REQUEST FOR INFORMATION

PROJECT	:	CADANGAN PEMBINAAN BALAI BOMBA DAN PENYELAMAT BEAUFORT SABAH					
ISSUED TO	:	KIA			ISSUED DATE	:	29.12.2020
ATTENTION	:	AR. NOOR IZWAN RAHIM			RF Info No.	:	RF Info/BOMBA/ 04
DESIGNATION	:	PRINCIPL					
C.C	:						
This RFI will Constitute	:	☐ Variation Oder	☐ Time Extension		☐ N/A	PIC Siganture

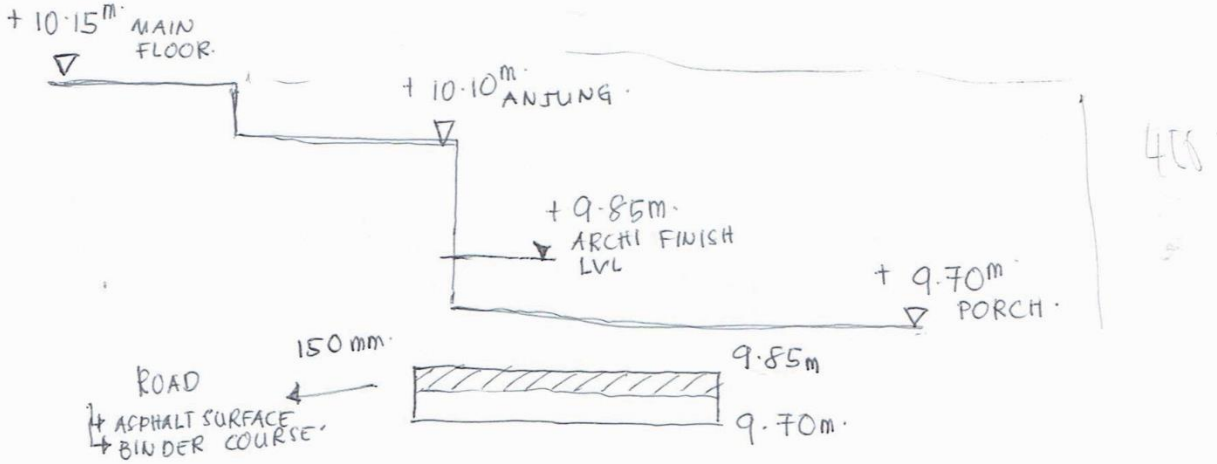
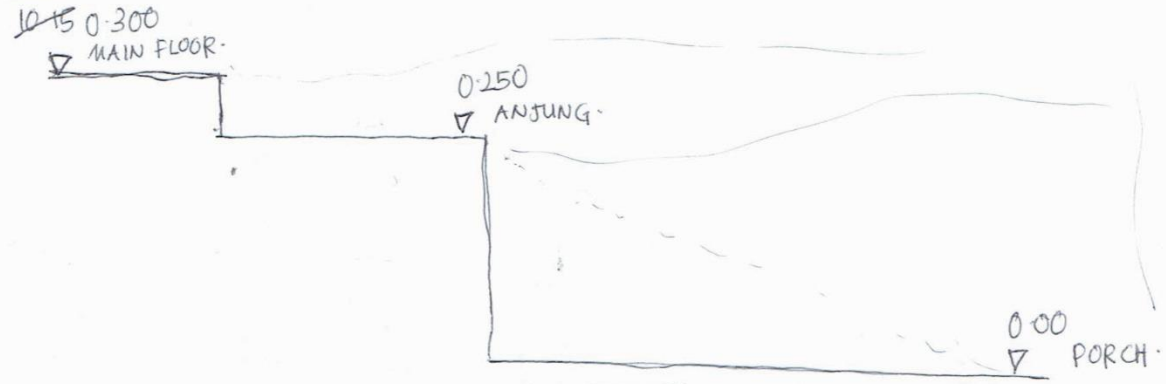
1. Confirmation of finish floor level.

→ ± 9.85M finish level for porch area.
C & S drawing.

→ ± 0.00M at Archt drawing.

C&S.

+ 10.15m MAIN FLOOR.
+ 10.10m ANJUNG.
+ 9.85m. ARCHI FINISH LVL
+ 9.70m PORCH.
150 mm.
ROAD
ASPHALT SURFACE
BINDER COURSE.
9.85m
9.70m.

ARCHI.

~~10.15~~ 0.300
MAIN FLOOR.
0.250
ANJUNG.
0.00
PORCH.

For the floor finish level (FFL), please follow as per C&S drawing.

But you are responsible to make sure the drop from 'Ruang Lobi' to 'Anjung' is 50mm fall slope as per 'Cadangan Penambahbaikan Rekabentuk' drawing from us which has been agreed and approved by JBPM and USB KPKT.

AFK should provide to you their revised drawing pertaining to this different level between 'Ruang Lobi' and 'Anjung'.
